Revision Control Record

Description:
MASTER DISCONNECT SW.

Drawing / Part No.: **75908** **B**

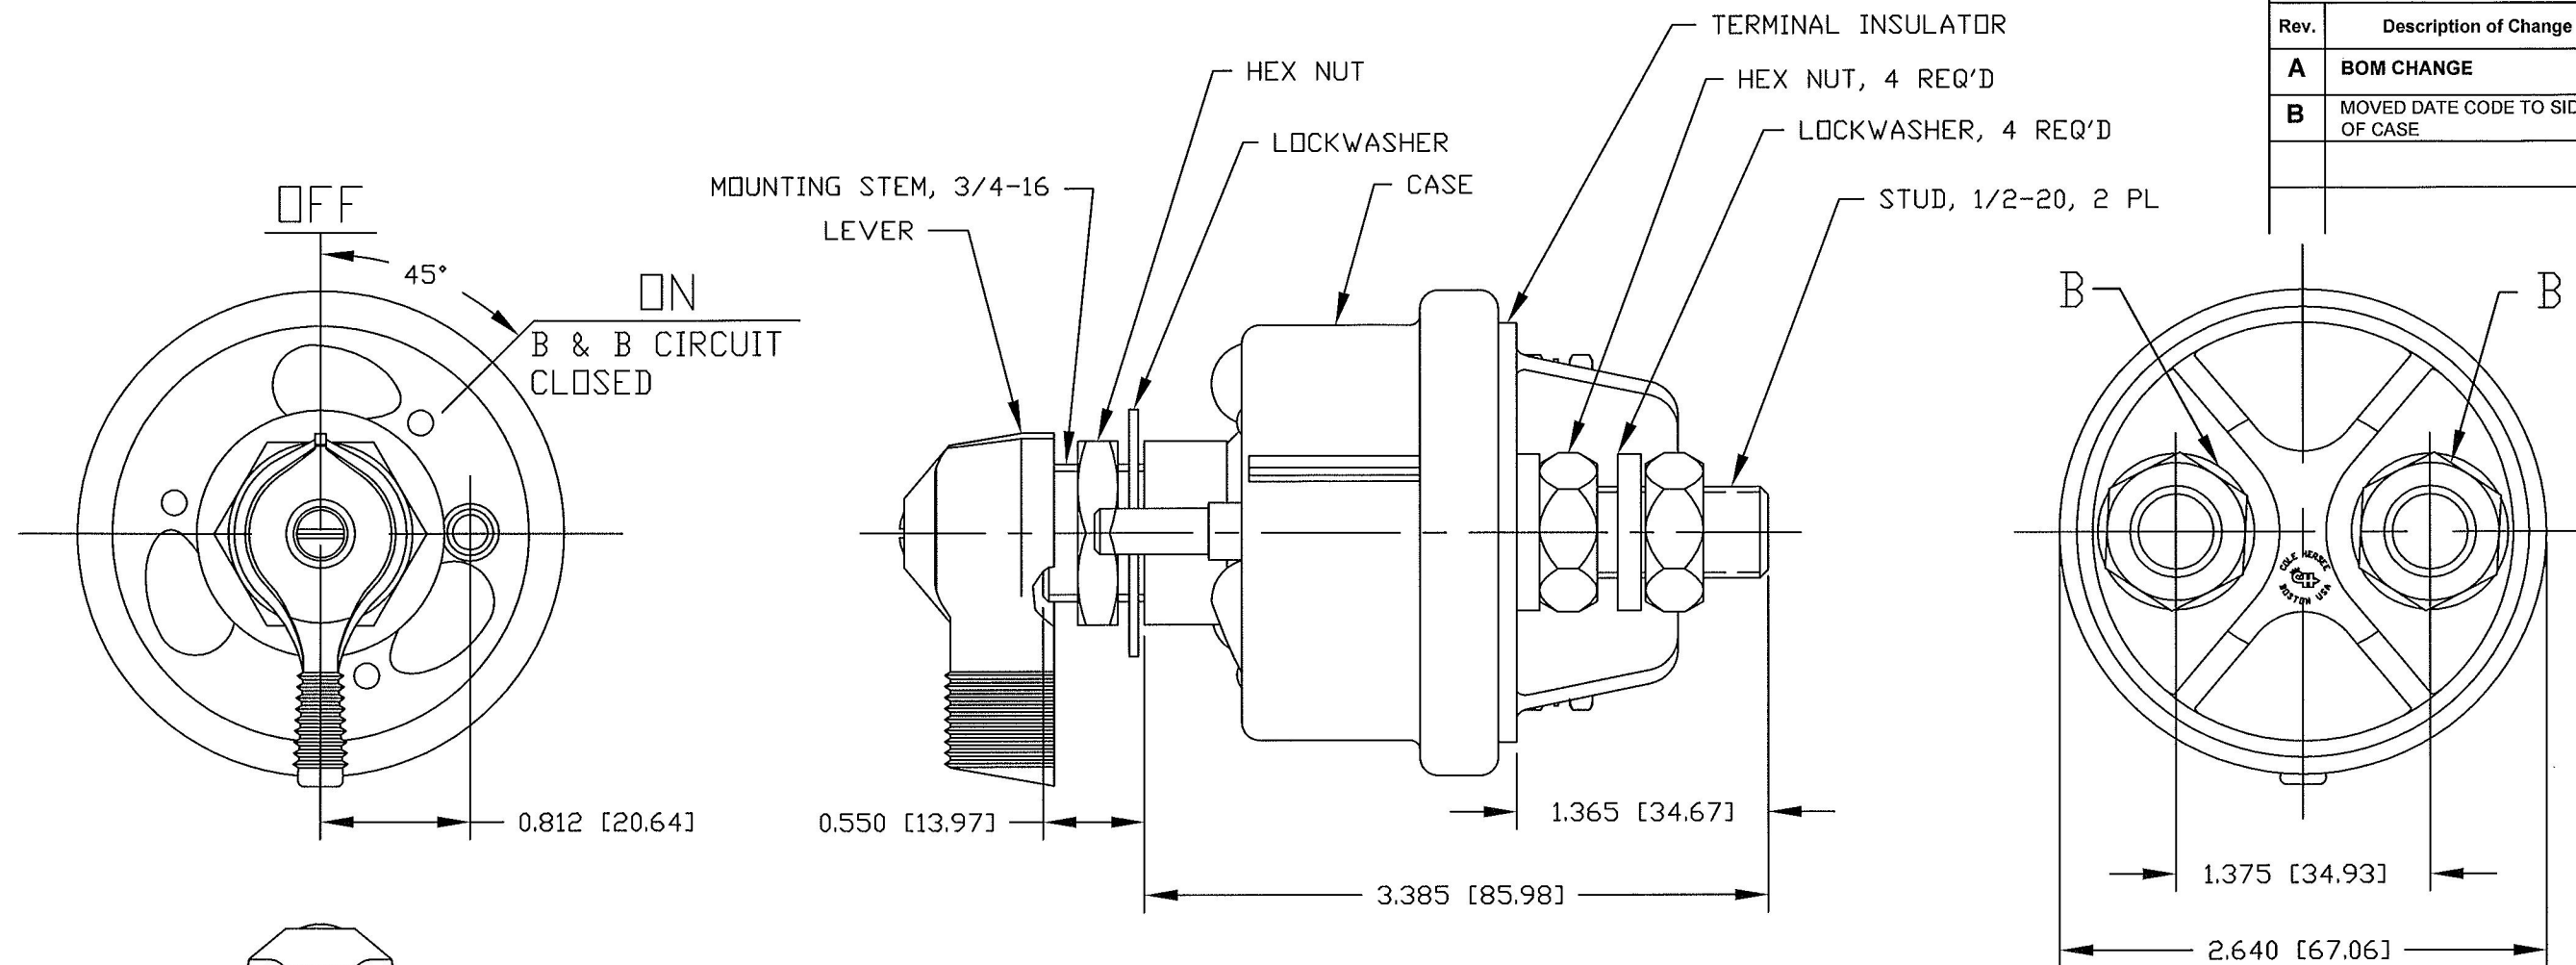
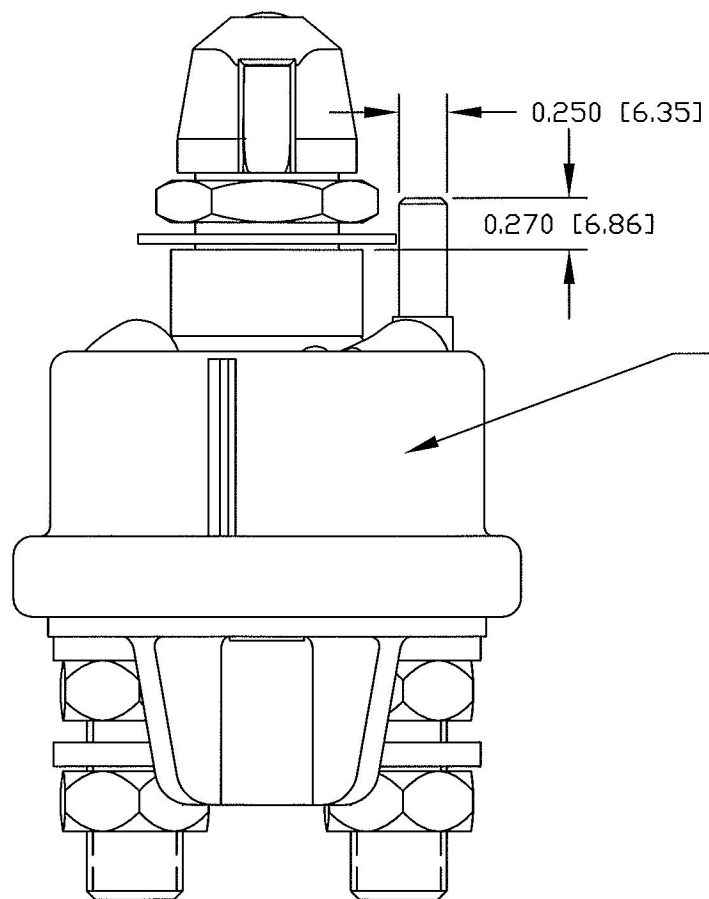
Rev.	Description of Change	ECN No.	Date
A	BOM CHANGE	06273	08/17/06
B	MOVED DATE CODE TO SIDE OF CASE	10331	9/14/10

MARK PART NUMBER & DATE CODE ON THIS SURFACE

(B)
